STATE OF RHODE ISLAND AND PROVIDENCE PLANTATION  
DEPARTMENT OF TRANSPORTATION  
RHODE ISLAND CONTRACT NO.2012-CB-046  
FEDERAL-AID PROJECT NO. FAP Nos: BRO-0200(007)

**Washington #200 - Pedestrian Bridge & Warren Avenue Bridge #464**

NOTICE TO PROSPECTIVE BIDDERS

ADDENDUM NO. 3 Prospective bidders and all concerned are hereby notified of the following changes in the Plans, Specifications, Proposal and Distribution of Quantities for this contract. These changes shall be incorporated in the Plans, Specifications, Proposal and Distribution of Quantities, and shall become an integral part of the Contract Documents.

<b>REVISION TO TYPICAL SECTION 1</b>	<b>RI CONTACT NO. 2012-CB-046</b>	<b>SKETCH NO.  1</b>
<b>APRIL 2, 2012</b>	<b>ADDENDUM NUMBER 3</b>	<b>REVISION TO SHEET NO. 6</b>

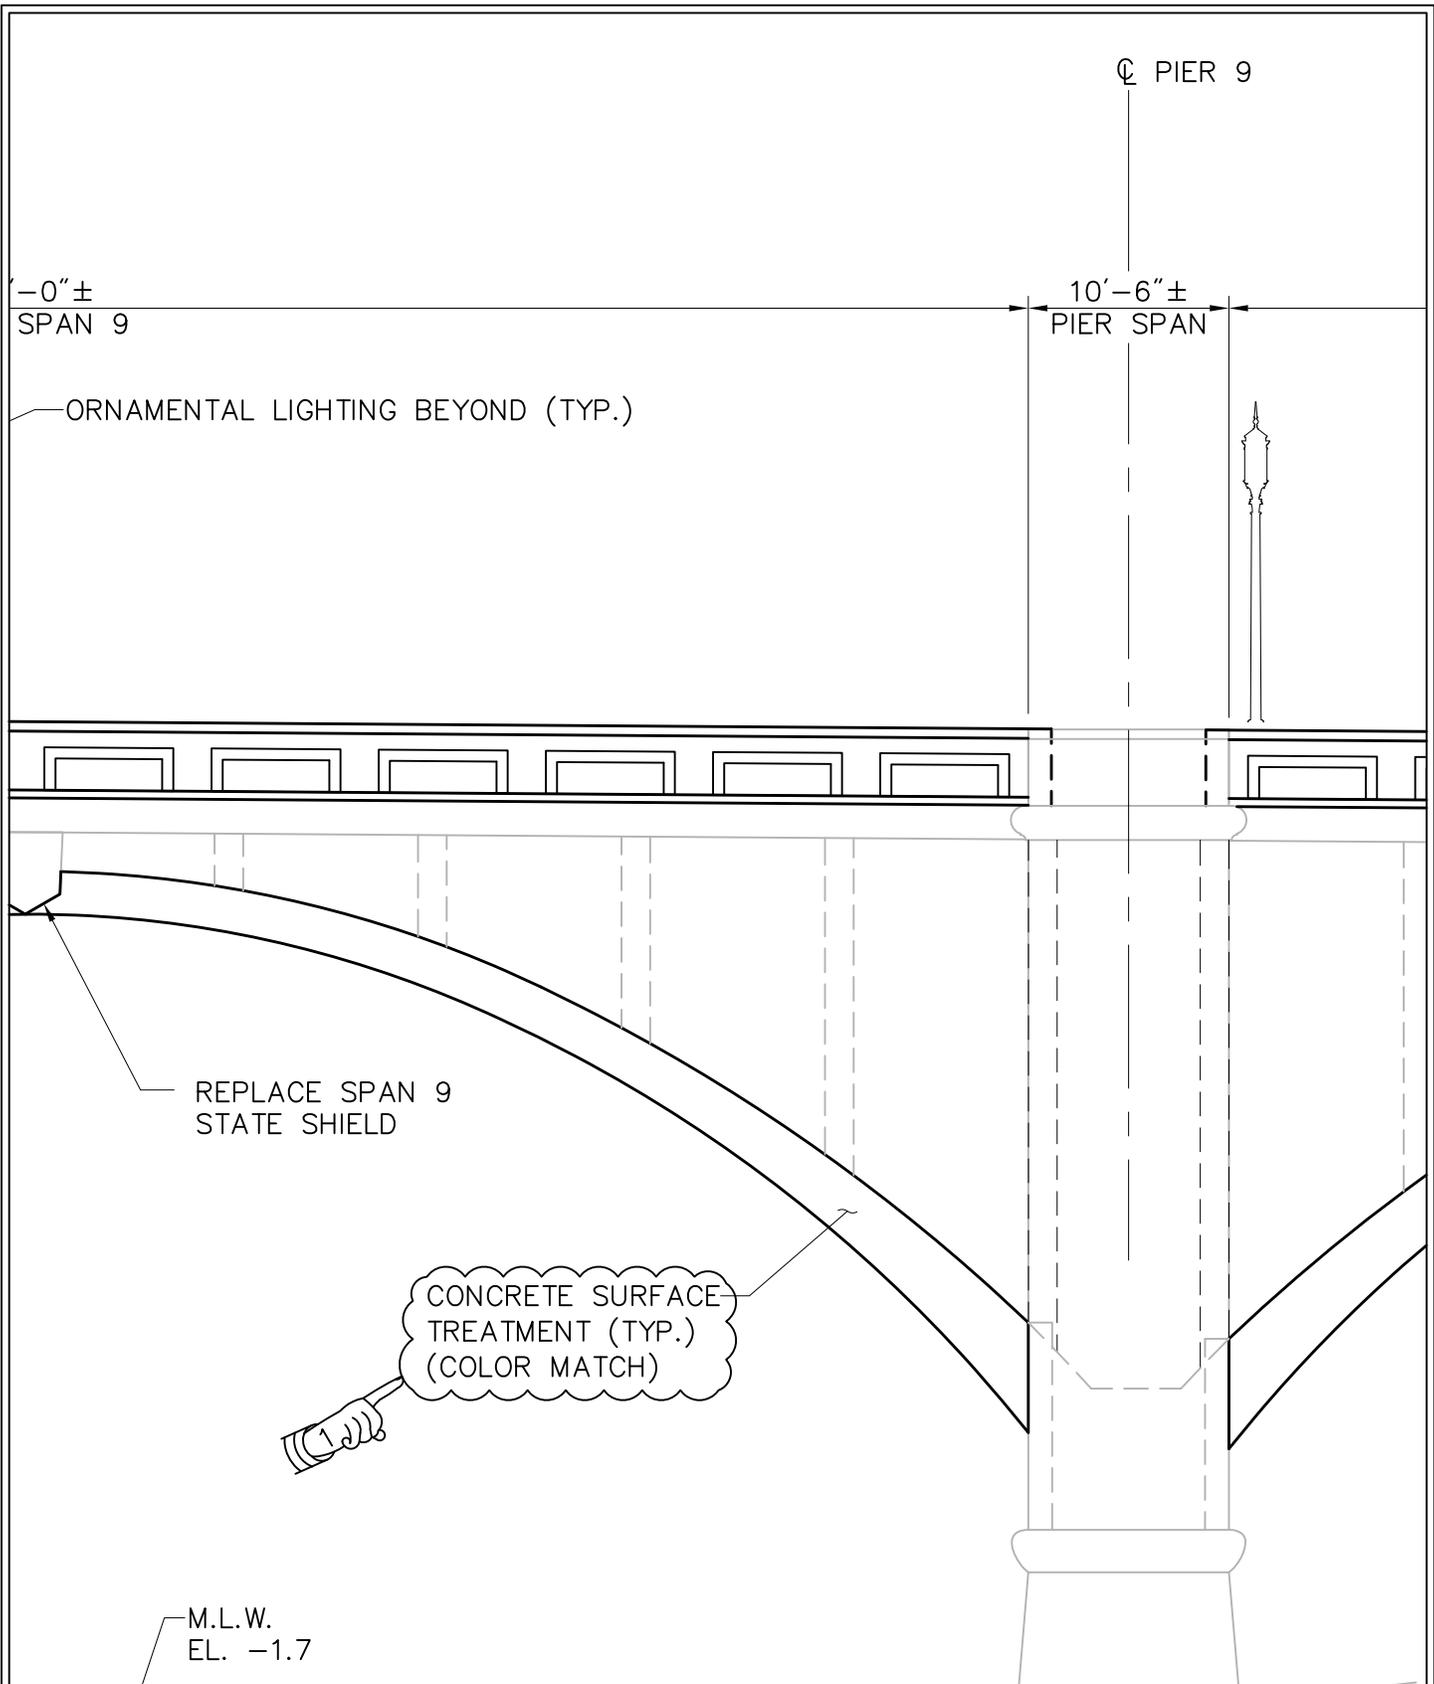
1. SET 3 SHEET NO. 6 - TYPICAL SECTION 1  
Modify the plan as shown on Sketch No. 1 attached to this Addendum No. 3. Concrete surface protective coating with color tinting has been added to the substructure and Span 14 & 15.

6. CONTRACTOR SHALL PROVIDE A COLOR MATCH SUBMITTAL IN ACCORDANCE WITH ITEM CODE 820.9901 "CONCRETE SURFACE TREATMENT PROTECTIVE COATING WITH COLOR TINT".

REVISION TO SHEET NO. 15

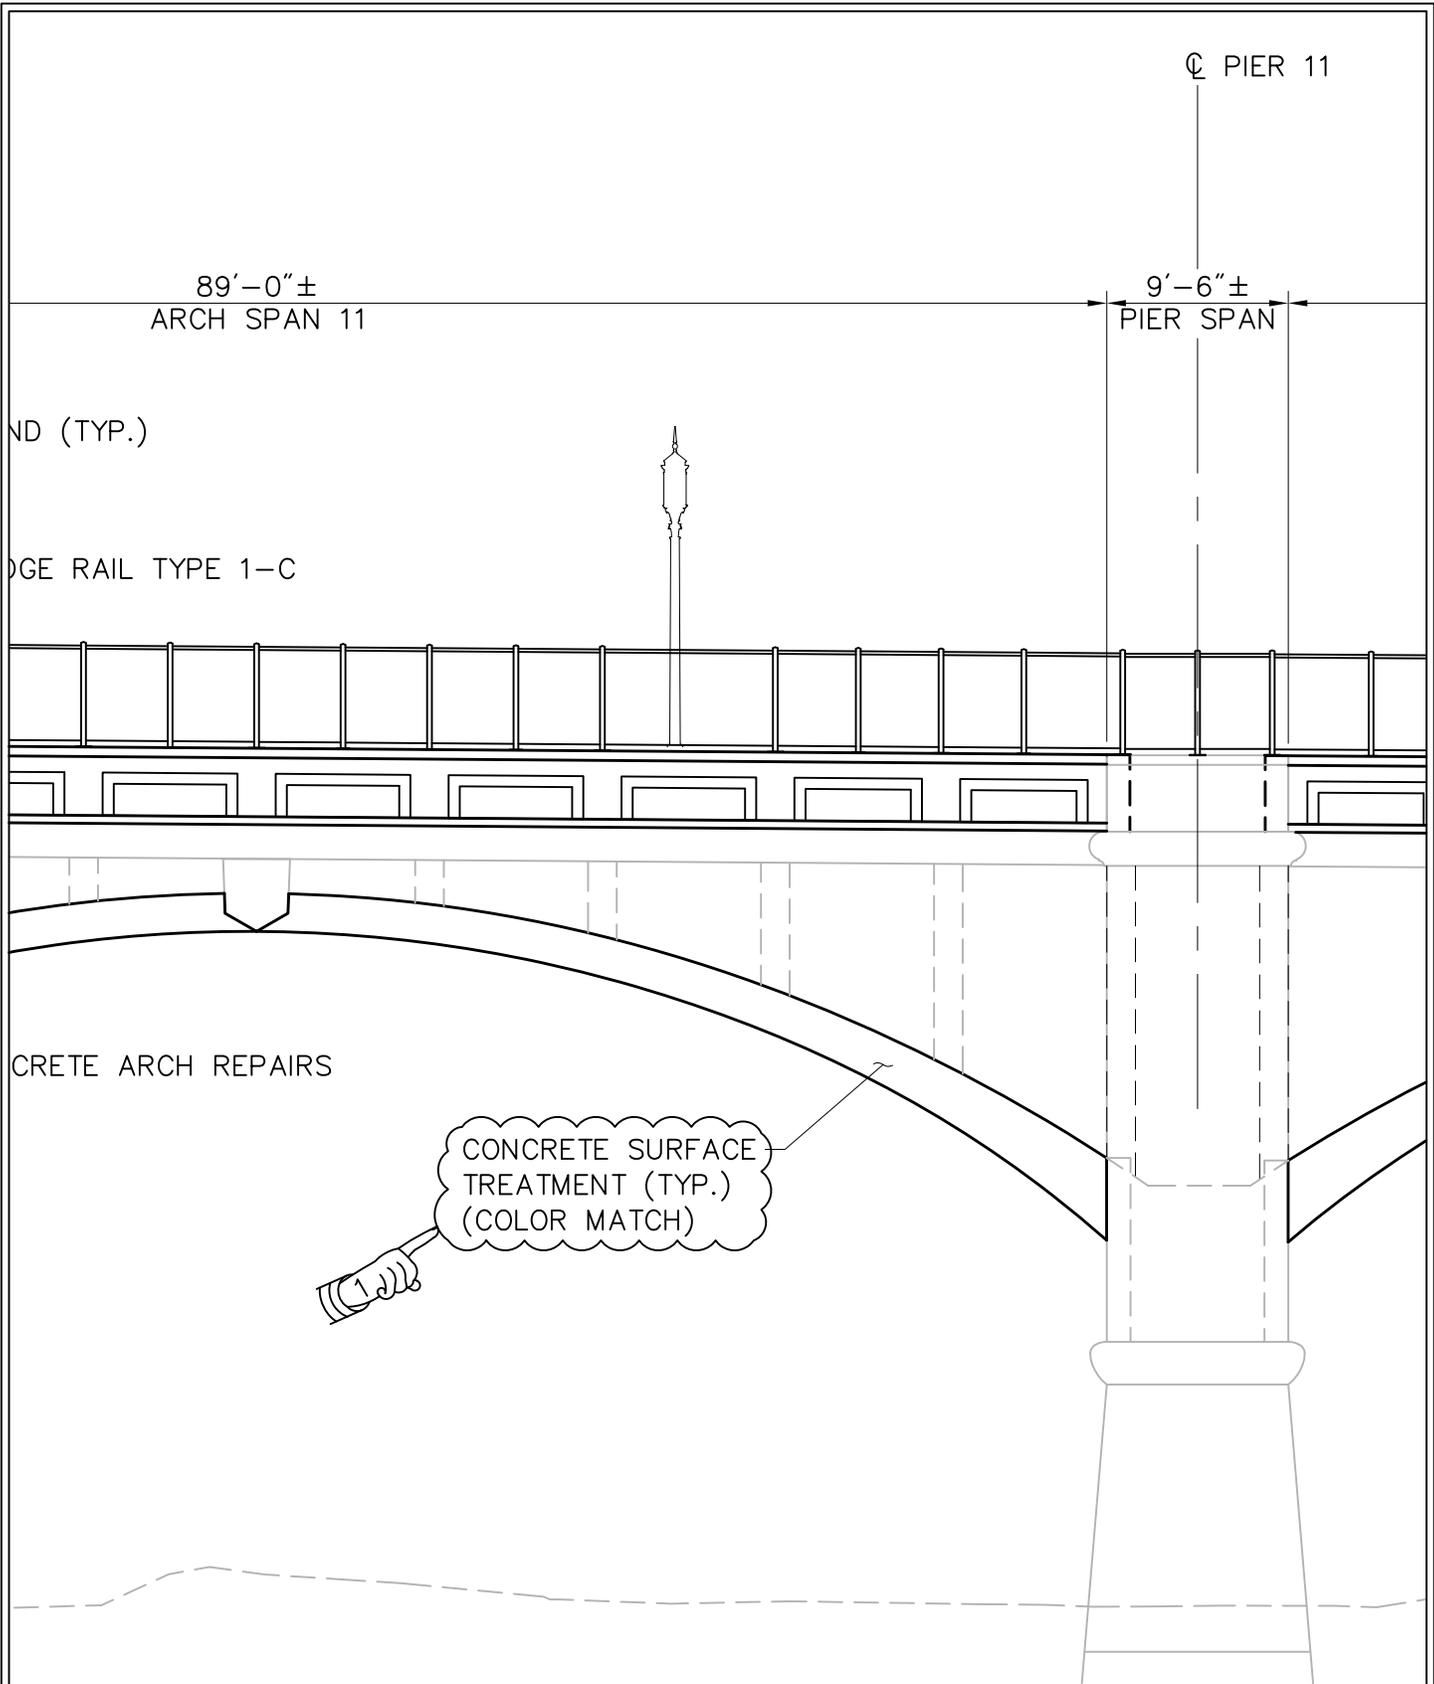
2. SET 3 SHEET NO. 15 - BRIDGE GENERAL PLAN AND ELEVATION 6  
Modify the plan as shown on Sketch No. 2 attached to this Addendum No. 3. Spans receiving the concrete surface treatment on the arch ribs have been clarified.

**REVISION TO SHEET NO. 16**

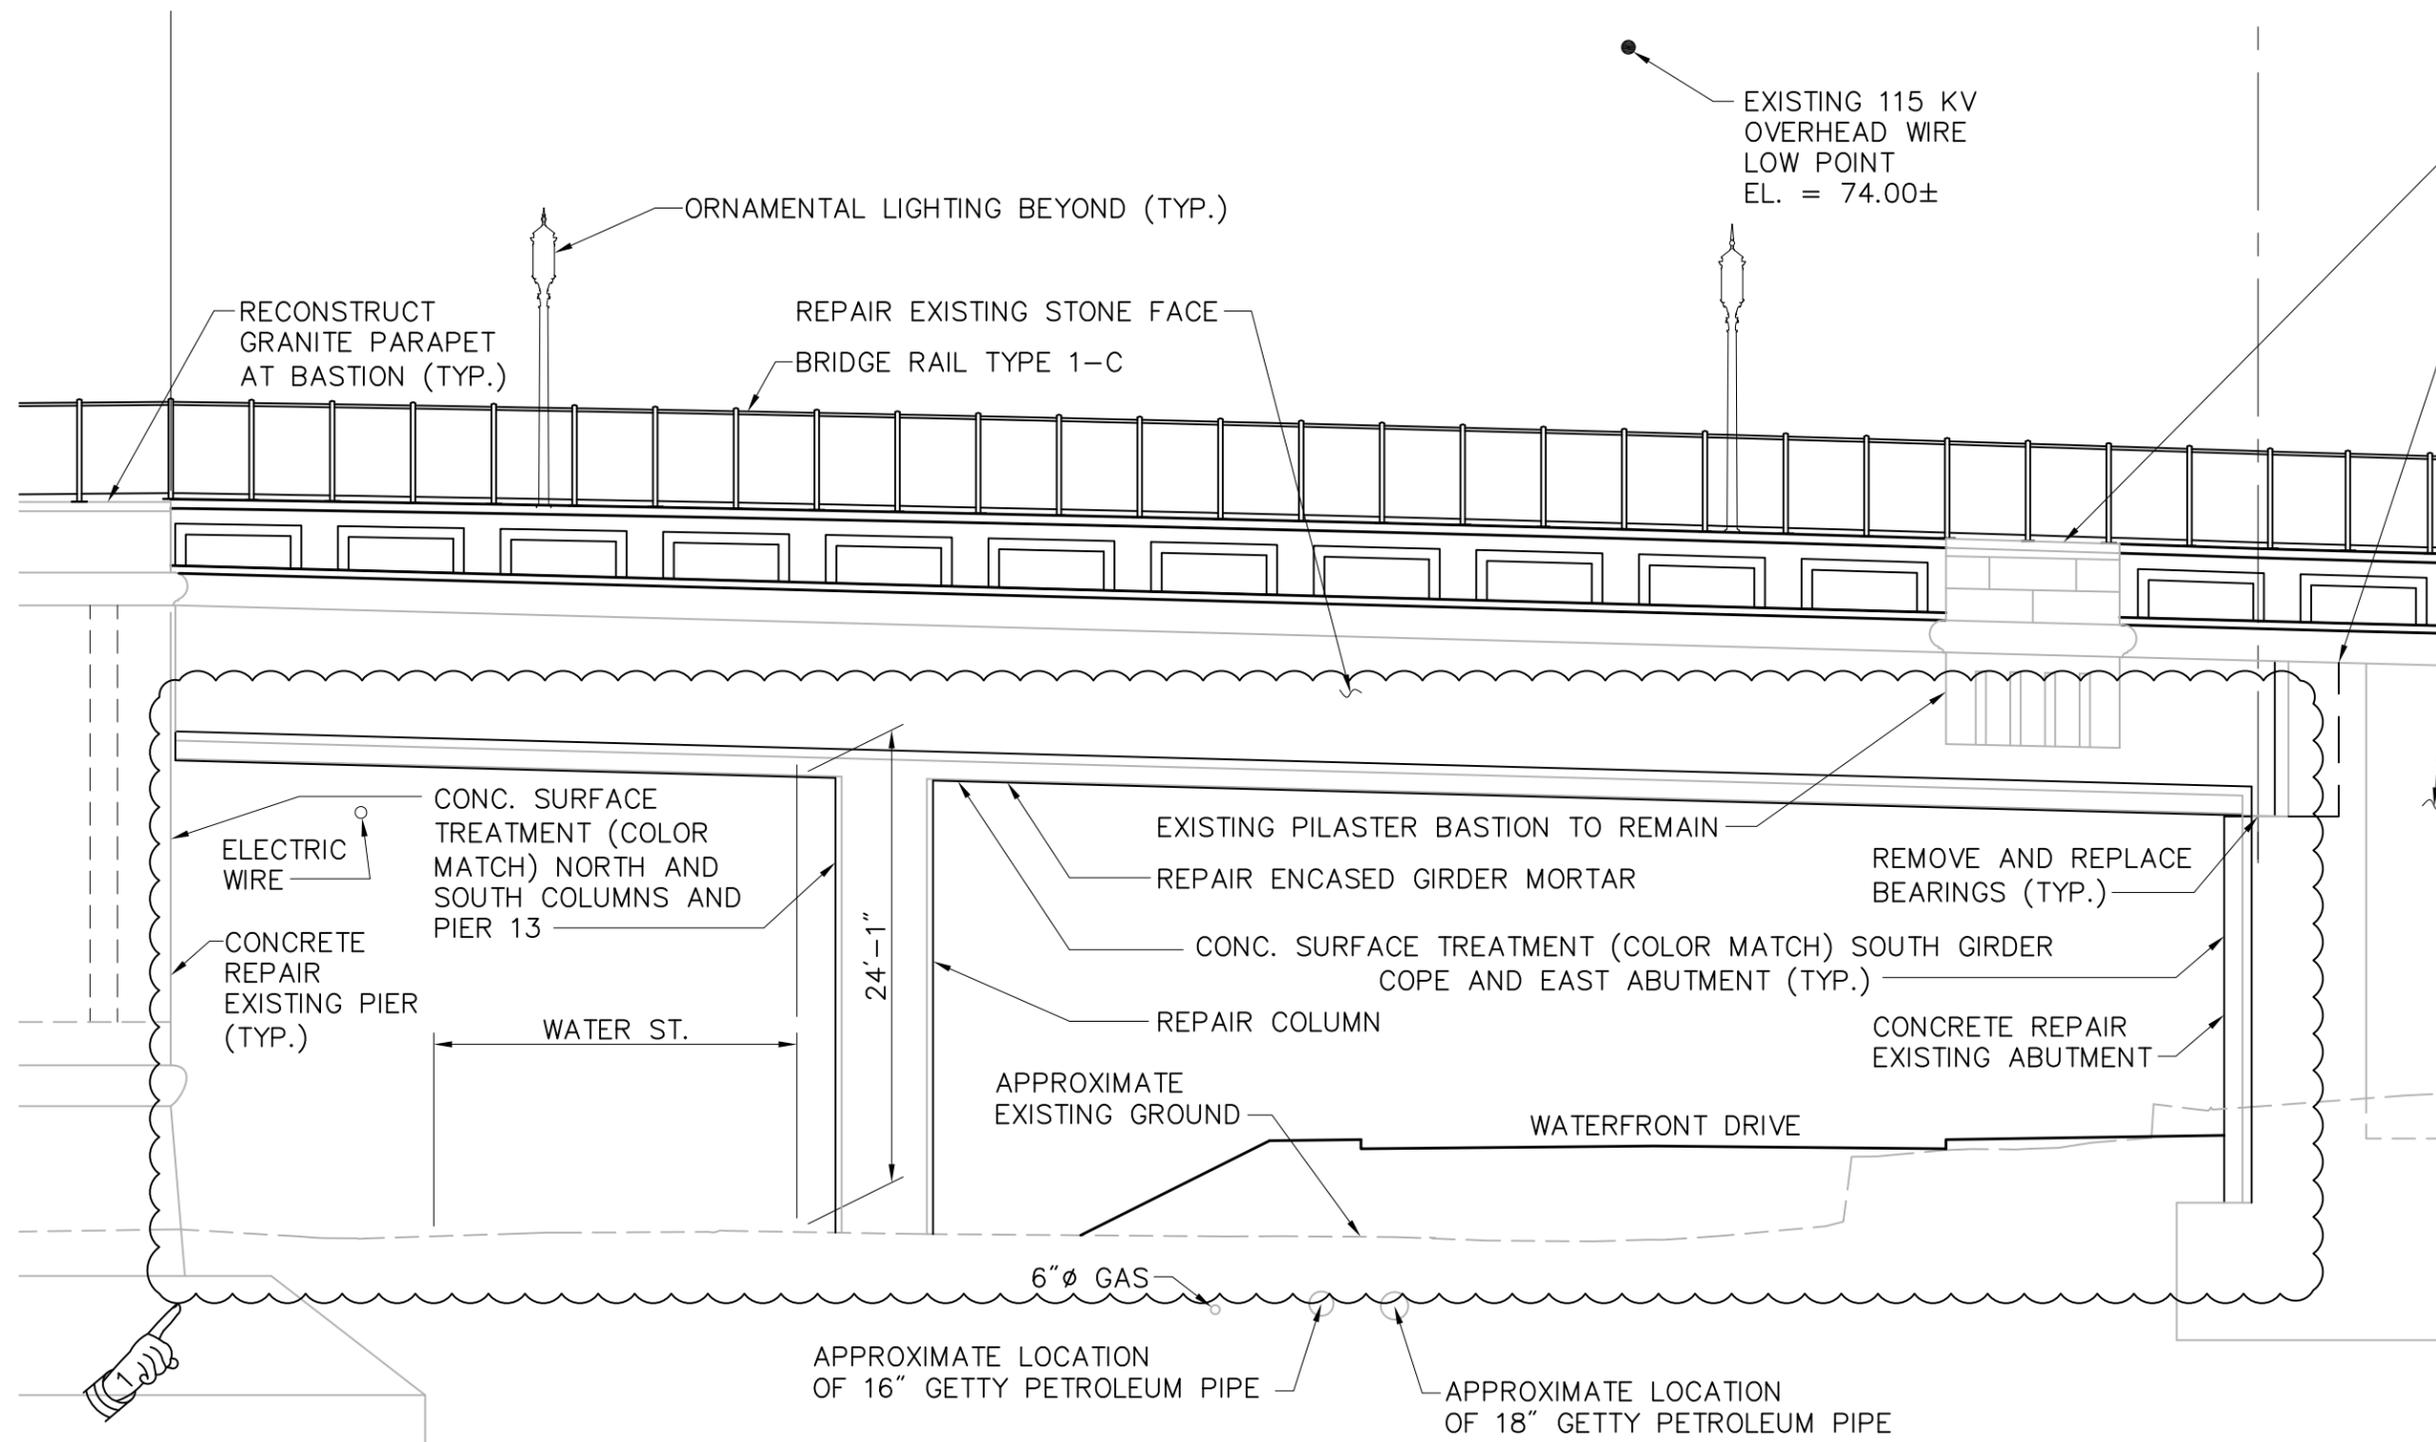
3. SET 3 SHEET NO. 16 - BRIDGE GENERAL PLAN AND ELEVATION 7  
Modify the plan as shown on Sketch No. 3 attached to this Addendum No. 3. Spans receiving the concrete surface treatment on the arch ribs have been clarified.

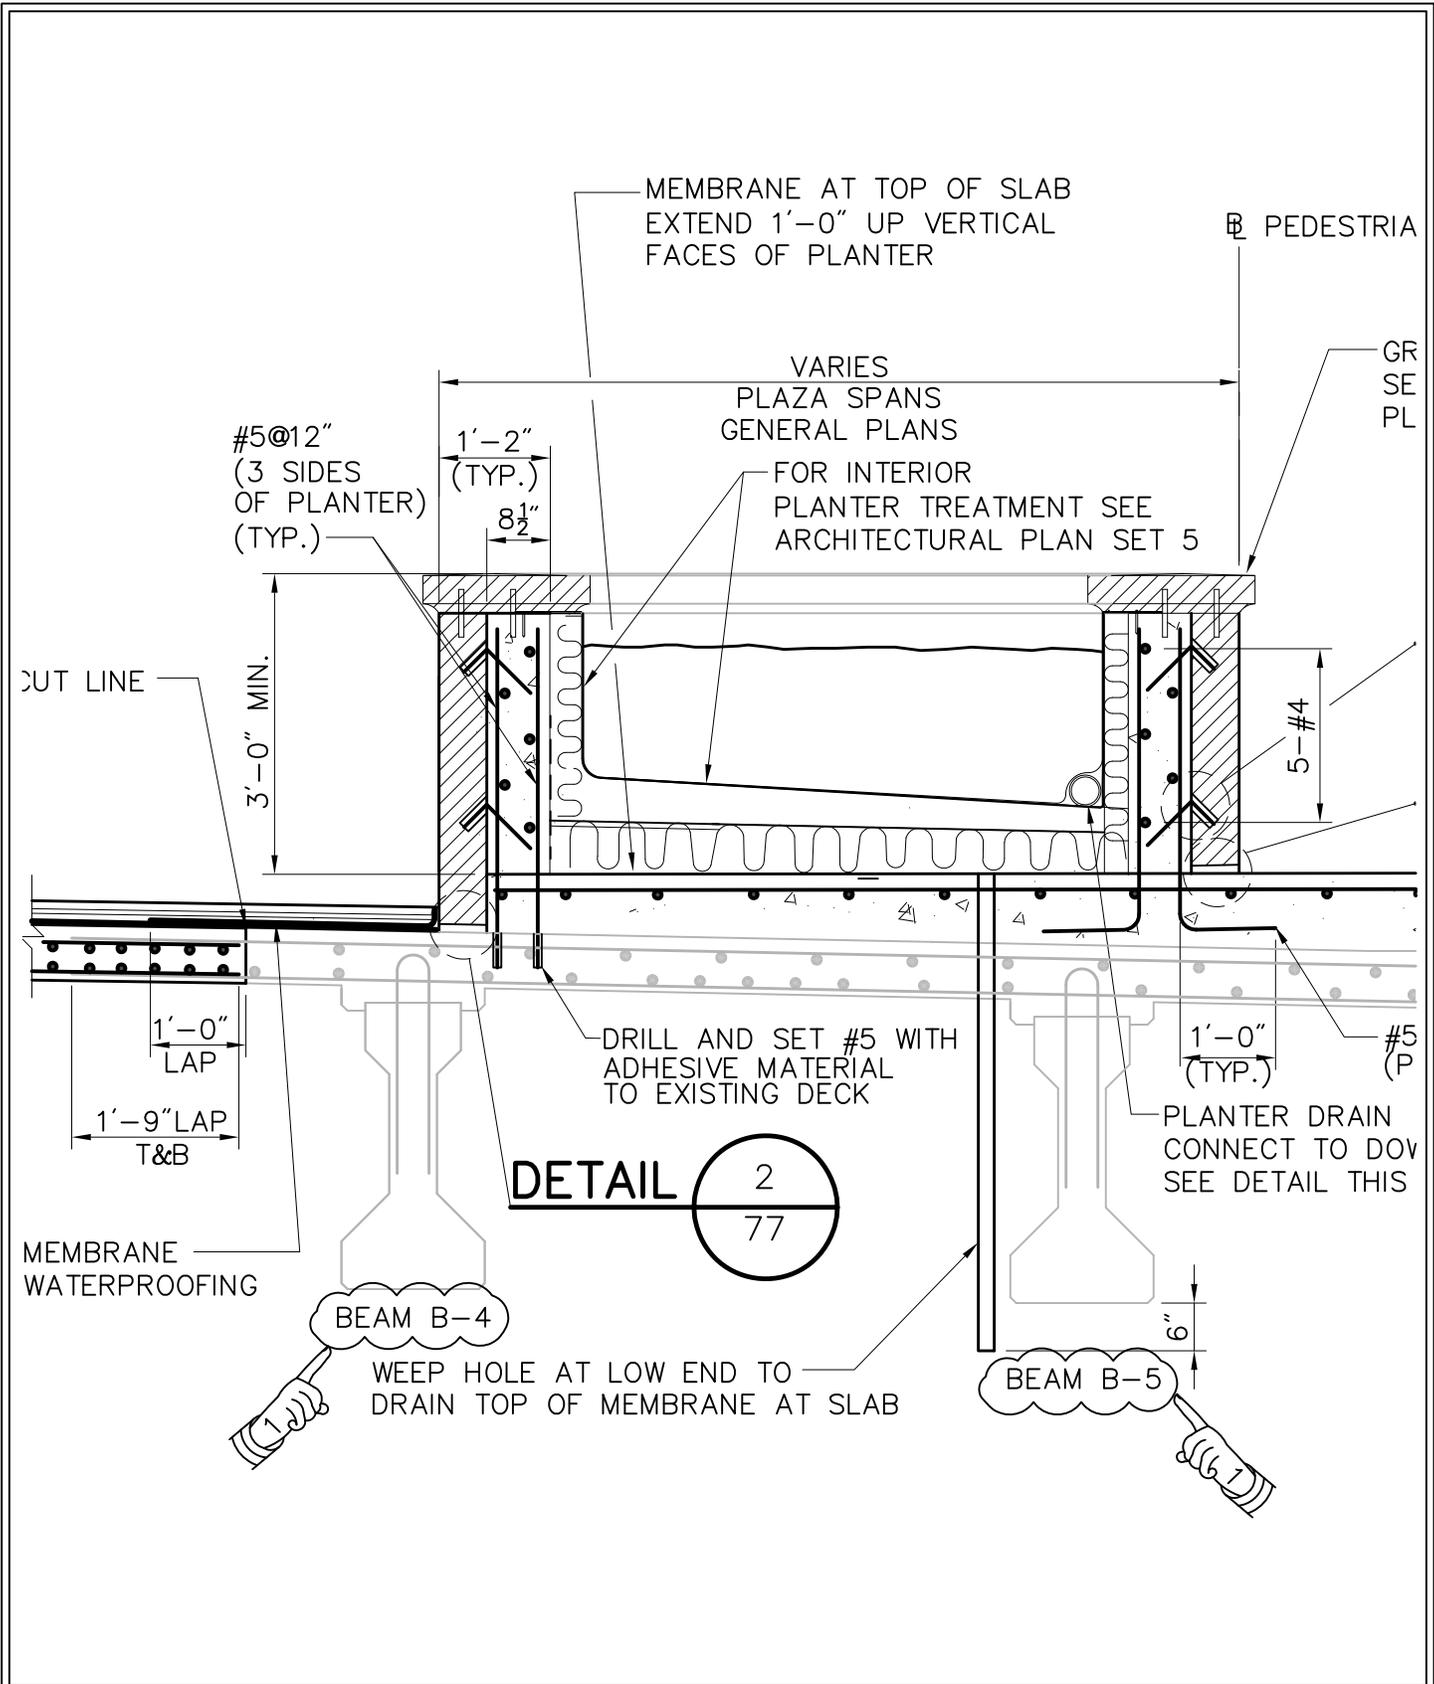
8. SET 3 SHEET NO. 68 - SPAN 6A AND 7A PRESTRESSED BEAM DETAILS 1  
Modify the plan as shown on Sketch No. 8 attached to this Addendum No. 3. Beam B3 is shown as an existing beam. Note No. 3 has been added.

1. FOR EXISTING BEAM, MAINTAIN EXISTING DOWEL BAR DURING DEMOLITION OF END DIAPHRAGM. CLEAN AND BLAST CLEAN RUSTED REBARS AS NEEDED.

2. AT UTILITY OPENING, MAINTAINS 2" CLR FOR DOWEL BAR.
